Mask Set Errata for Mask 1M00S

This report applies to mask 1M00S for these products:

- MCF51EM256
- MCF51EM128

See following flow chart for the workaround example described above:

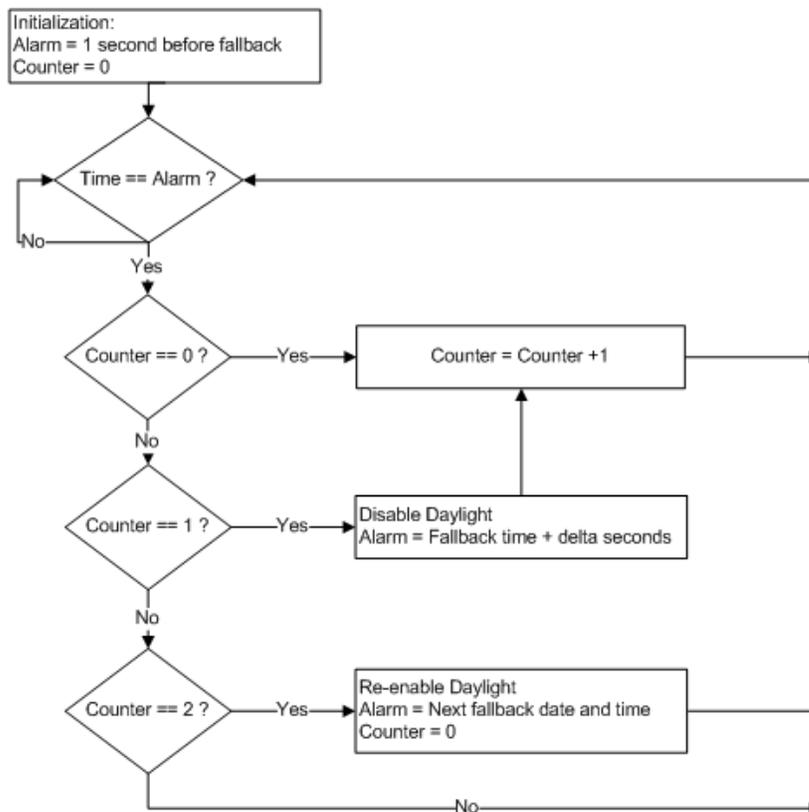
Description: iRTC repeatedly loops within the hour after Daylight Saving Time (DST) falls back. This erratum only impacts iRTC when daylight saving falls back. Other features including DST forward are not impacted.

In the example above, the iRTC correctly rolls from 15:59:59 to 15:00:00 when fallback occurs. After the fallback occurs, the next hour roll over should be from 15:59:59 to 16:00:00 but it is incorrectly roll back to 15:00:00. iRTC then falsely loops between 15:59:59 and 15:00:00 repeatedly.

Workaround: This issue can be resolved by software where the iRTC Alarm feature disables the DST after the fallback event occurs. Then re-enables the DST after the iRTC passes the next hour (e.g after 16:00:00). Make sure the DST is re-enabled before the next DST event occurs.

Following is an example of the workaround:

15:59:59 -> 1st alarm (counter ==0)

- 15:59:59 falls back to 15:00:00
- In Alarm interrupt service routine :
 - Update software counter = 1 ;
 - Re-configure next alarm to a time before the next 15:59:59 roll over. In this example we keep the alarm time same as the first one at 15:59:59.

15:59:59 -> 2nd alarm (counter ==1)

- In Alarm interrupt service routine:
 - Disable DST feature. This allows 15:59:59 to correctly roll to 16:00:00
 - Re-configure next alarm to a time after 16:00:00. We recommend choosing a time long enough to account for alarm interrupt service routine execution time. Testing showed that with 15 seconds after roll over time is a safe delay. In this example the next alarm is set to 16:00:15
 - Set software counter = 2;

16:00:15 -> 3rd alarm (counter ==2)

- Re-enable DST feature so that the next DST event can occur.
- Re-configure alarm to the next DST fallback date and time
- Reset counter (counter = 0)
